Proposal to modify SUS alignment offset handling

SUS ALIGN OFFSETS: current

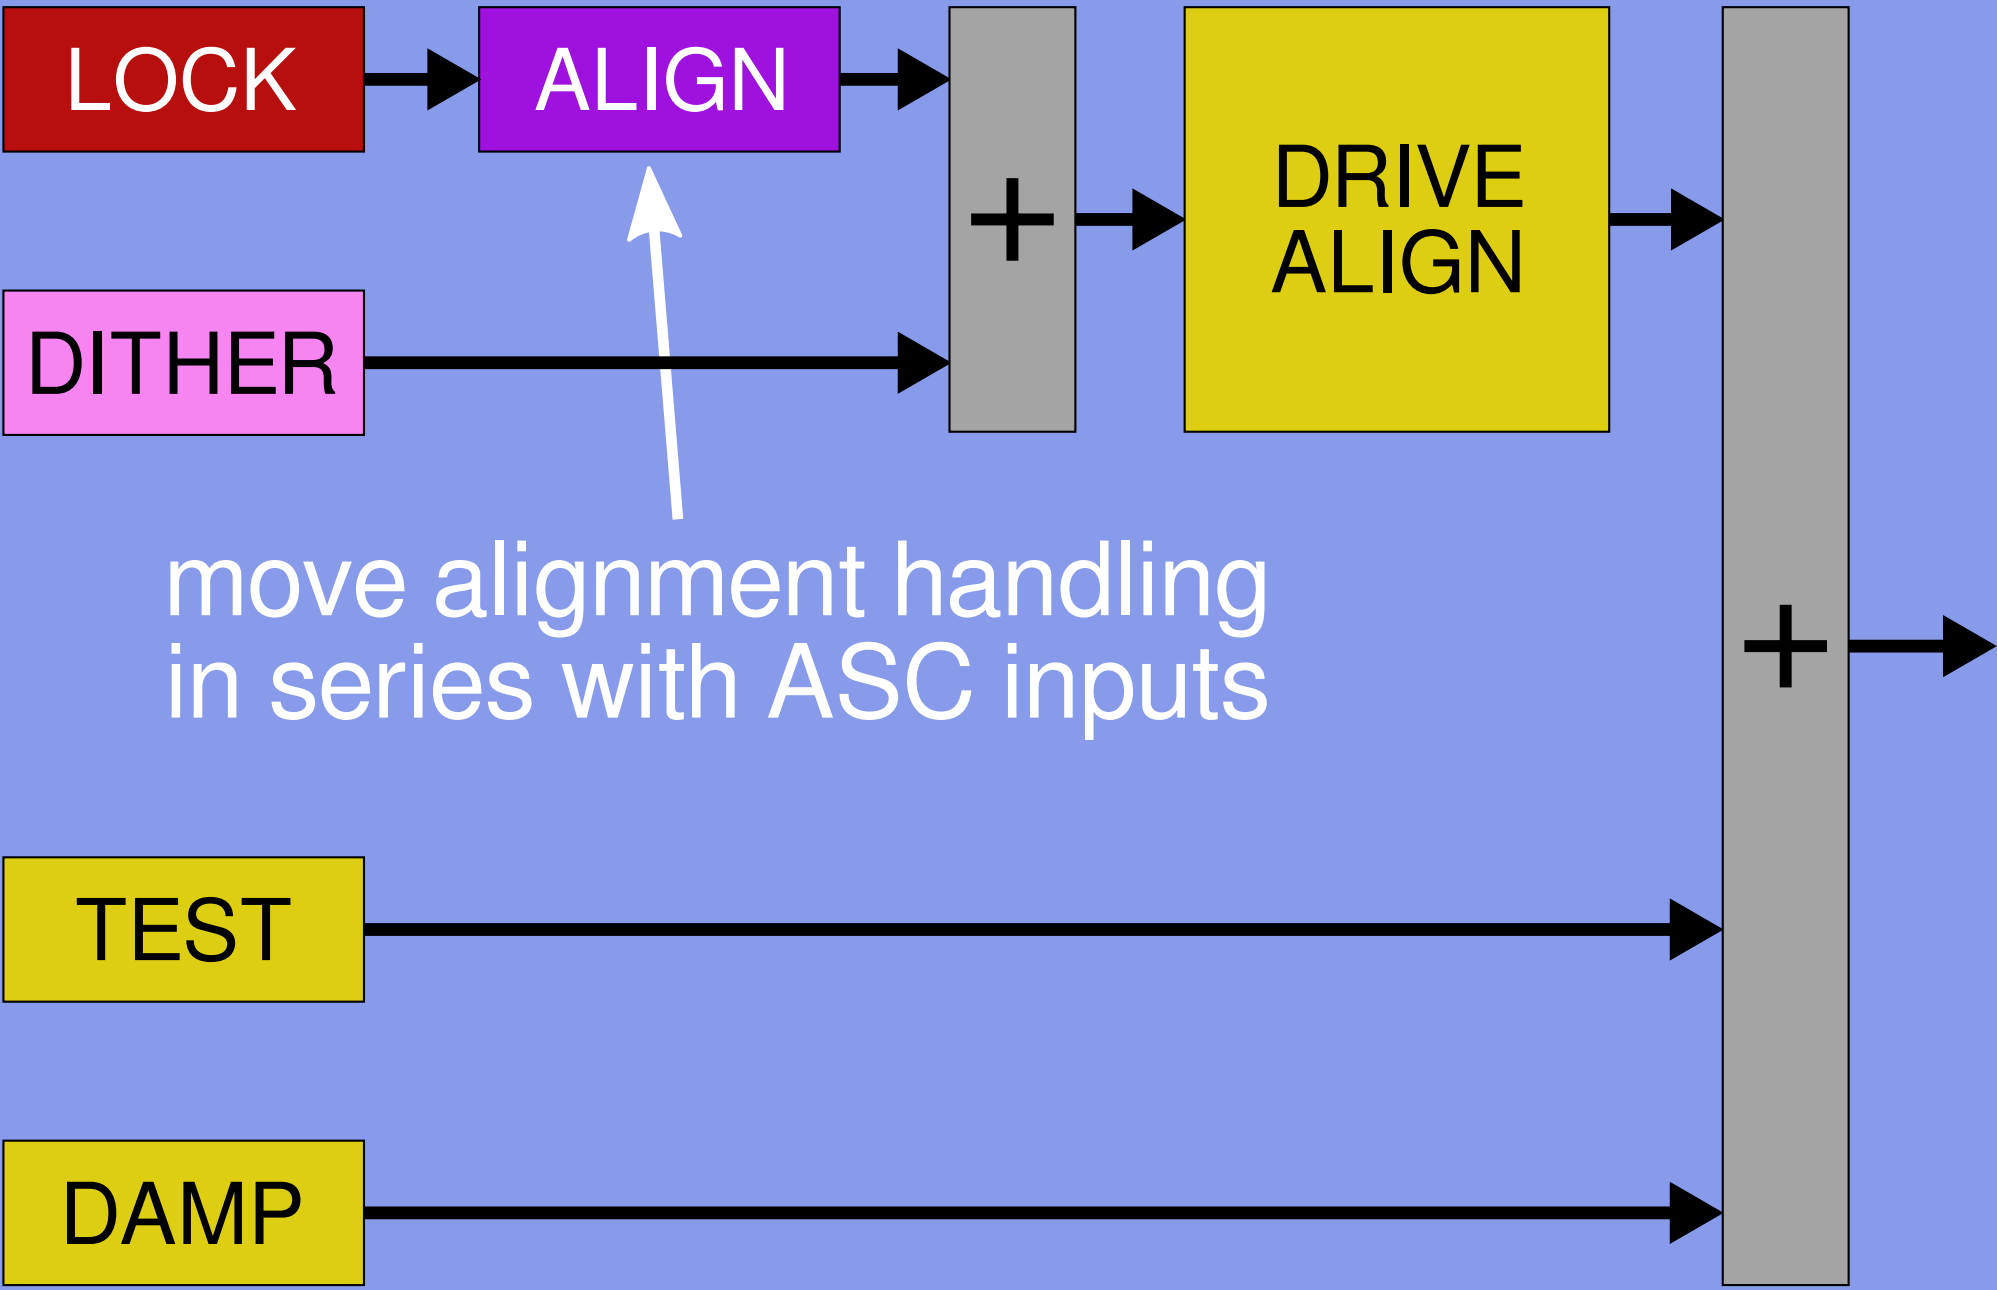
goals:

- separate records for mis/alignments offsets, allow switching without rewriting values
- store mis/alignments separately in frames
- handle "fixed" or "sum" misalignment offsets
- "glitch free" ASC DC offloading

SUS ALIGN OFFSETS: proposed

move alignment handling
in series with ASC inputs

SUS ALIGN OFFSETS: detail

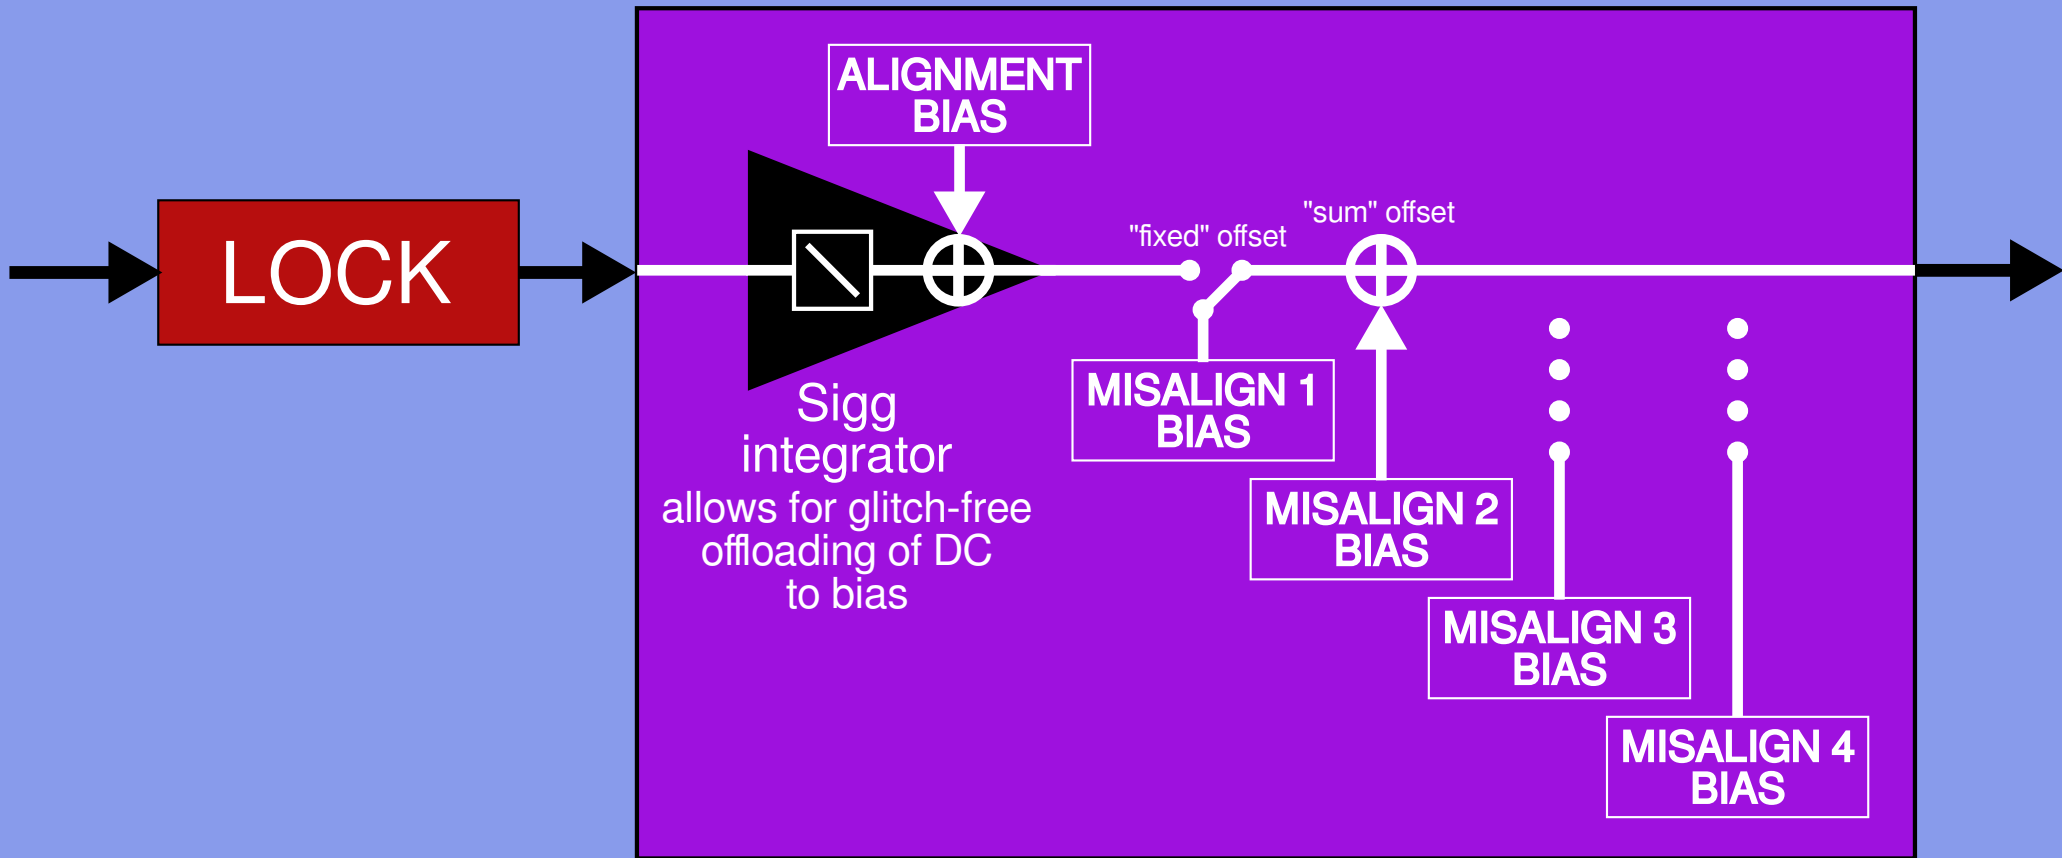
support 4 misalignments, each independently selectable as "fixed" or "sum"
